SI B33 04 16
Rear Axle

SERVICE ACTION: REPLACE REAR-AXLE DIFFERENTIAL

This Service Information bulletin supersedes SI 33 04 16 dated August 2016

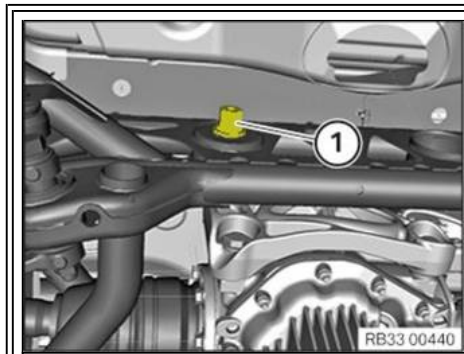
During the repair, when releasing rear differential Hexagonal collar bolt M14x1.5x125 (PN 33 17 7 852 488), make sure that the bolt's hex head does not show any marks indicating previous removal. In case bolt M14x1.5x125 (1) has been removed (torque released) previously, it needs to be replaced together with 4 sub-frame Torx screws M12x60 (PN 33 30 2 284 642).

F8x produced up to 06/28/2016

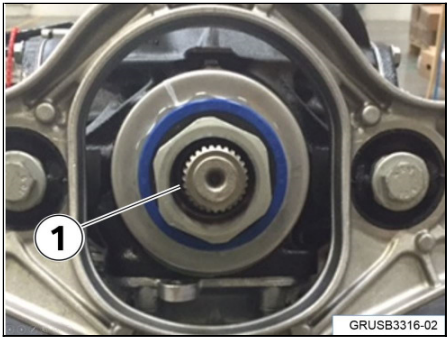
<p>Identifying the 8 090 464 differential: Check the number of splines on the old/new differential. The correct differential has 35 splines (1)</p>
--	--
